IN THE UNITED STATES PATENT AND TRADEMARK OFFICE

Applicant: ANTHONY MAGLICA)	Group Art Unit: 2901
Serial No. 07/411,576)	Examiner: M. Tung
Filed: September 22, 1989)	
For: FLASHLIGHT)	
)	
)	
)	
)	
)

AMENDMENT AFTER FINAL REJECTION

FIG. 1.

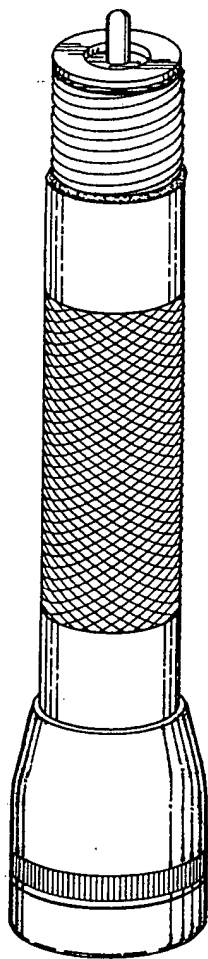
The treatment at the uppermost end as found in Figures 1 and 2 has also been varied. The outer flange of element 47 is shown above the threaded end of the barrel. This flange 47 is displaced slightly above the end of the barrel as can best be seen in Figure 3 of the original supporting drawings where the head assembly has been displaced sufficiently to show the at rest state of the flange 47 relative to the end of the barrel. Figure 8 is believed to show the same arrangement, albeit without sufficient clarity.

FIG. 2.

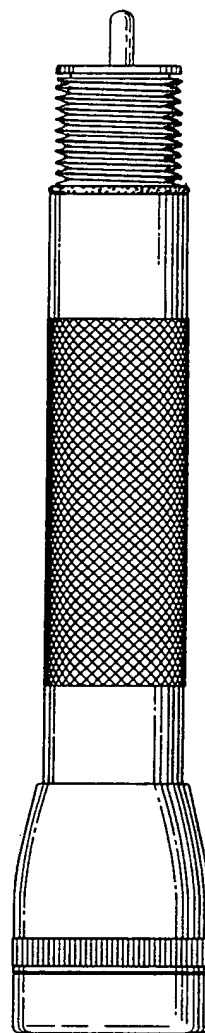
Regarding paragraph 13 of the Official Action, the proportions of the threaded portion have been amended as indicated in red in the attached photoprint. The issue was the diameter of the threads adjacent to the light bulb as compared with the cylindrical body. The greatest detail in that regard in terms of the original disclosure is found on Figure 5. However,
